ST LEONARDS SOUTH DESIGN CHARRETTE

Outcomes and Recommendations Report

February 2020

Figure 7 - Sketch Design Circulation Plan (Note: this drawing is at sketch design stage only. Further testing and validation studies are required).

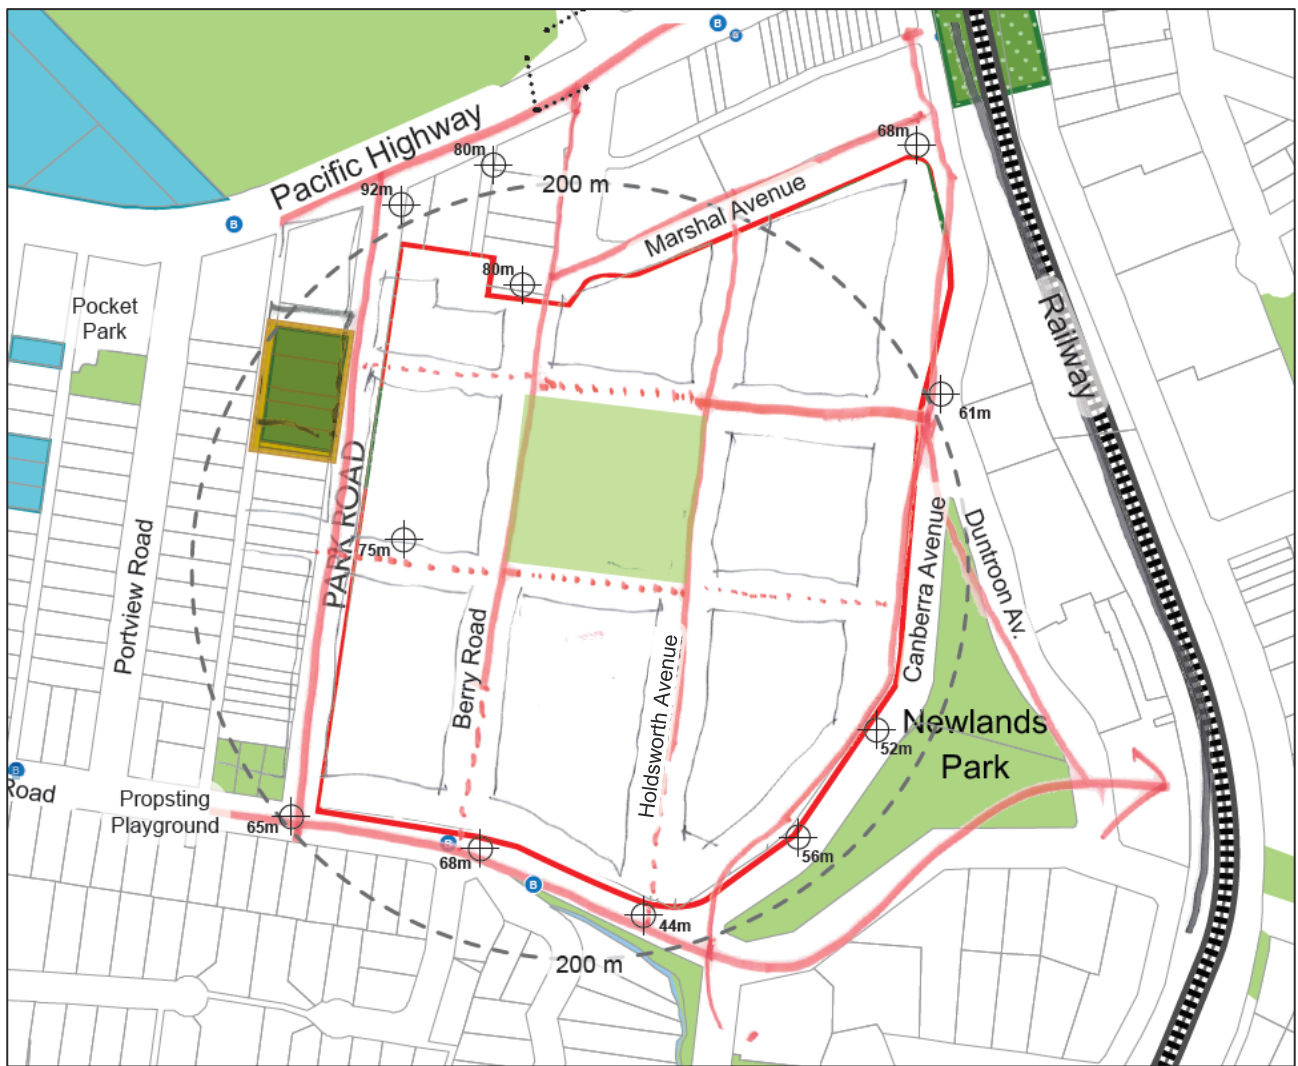
The panel drafted an illustration to help convey its abovementioned recommendations (**Figure 7**).

- Improved permeability through the site to key attractors.
- Greater links and vehicular circulation through the site, especially east-west.
- Use the open space as a core element of the pedestrian experience through the site.
- The journey through the site should be a 'journey through landscape', improving the pedestrian experience and removing the risk of monolithic buildings overbearing the through site links.
- Footpath widths on River Road should be increased, allowing separation from the high-volume road, tree planting to better reflect the character of the area, with wide shared path and landscape set back into the site.

- Creating multiple paths with reasonable grades will make the formalised east-west link redundant.
- Less emphasis on the formalised east-west link, decreasing the cost by removing the need for lifts within buildings, the management and maintenance of the access.
- These links could be later extended further west in the future through to Portview and Greenwich Roads.

The block pattern and increased number of through connections would provide new circulation opportunities through the development of new east west street links that can accommodate street trees and connected pathways (**Figure 5**).
